Item Name: Crosstube Turning Detail

DART AEROSPACE LTD		Work Order: 80514
Description: Crosstube Assembly (206B High Fwd)		Part Number: D206-667-141
Inspection Dwg: D206-667-141 Rev: C		Page 1 of 1

DRAWING NO. D206-667-141	TITLE CROSSTUBE ASS'Y (206B HIGH FWD)	REV. C	DART AEROSPACE LTD ENGINEERING ORDER		D.E.O. NO. D206-667-141-C-1	SHEET NO. SHEET 1 OF 1	SCALE NTS
DRAWN qp	CHECKED ASS	MFG. APPR. [Signature]	APPROVED [Signature]		DE APPR. [Signature]		
DATE 11.07.15	DATE 11.07.20	DATE 11.07.21	DATE 11/07/21		DATE 11.07.21

REPLACE MAGNOBOND WITH PROSEAL.

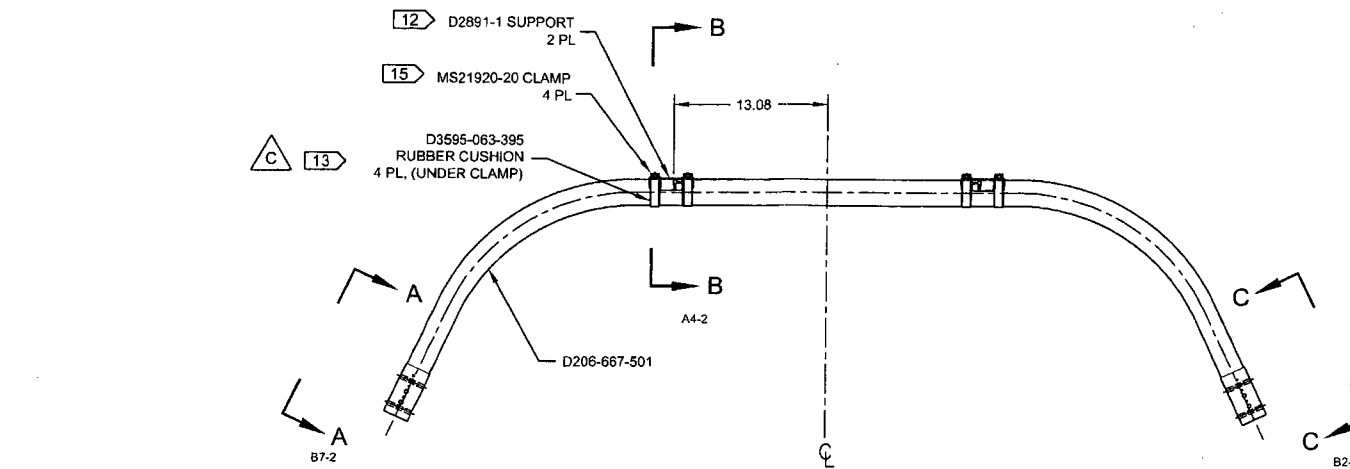
CHANGE:**IS:**

Item	Qty -141	Part Number	Description
9	A/R	PROSEAL 890 B-2	SEALANT, AMS-S-8802 CLASS B-2

WAS:

9	A/R	MAGNOBOND 6398	ROCKWELL SPECIFICATION RBO-120-023 ADHESIVE (TEXTRON/BELL SPEC. 299-947-100, TYPE II, CLASS 2 ADHESIVE)
---	-----	----------------	---

NOTE 12 & 15, SHEET 1 IS AMENDED AS FOLLOWS:

WAS:

- 12) INSTALL D2891-1 SUPPORT USING 0.03" TO 0.06" THICK LAYER OF MAGNOBOND 6398 PER QSI 015. LET CURE FOR 12 HOURS AFTER INSTALLATION AND PRIOR TO PACKAGING.
- 15) TORQUE CLAMPS 80 TO 100 IN-LB. ENSURE AT LEAST 1.5 THREADS SHOWING IN SAFETY AND THAT NUT HAS NOT BOTTOMED-OUT AFTER TORQUING.

- 12) TO INSTALL D2891-1 SUPPORT: ABRASE MATING SURFACE OF SUPPORT AND CROSSTUBE WITH 180-GRIT SANDPAPER AND REMOVE RESIDUE WITH MEK (OR EQUIVALENT). APPLY A 0.04" TO 0.07" THICK LAYER OF PROSEAL 890 CLASS B-2 (OR AMS-S-8802 CLASS B-2) SEALANT TO MATING SURFACE OF SUPPORT.
- 15) TORQUE CLAMPS 80 TO 100 IN-LB. ENSURE AT LEAST 1.5 THREADS SHOWING IN SAFETY AND THAT NUT HAS NOT BOTTOMED-OUT AFTER TORQUING. **PRIOR TO PACKAGING, RE-CHECK TORQUE ON CLAMPS AFTER PROSEAL 890 SEALANT HAS CURED FOR 72 HOURS.**
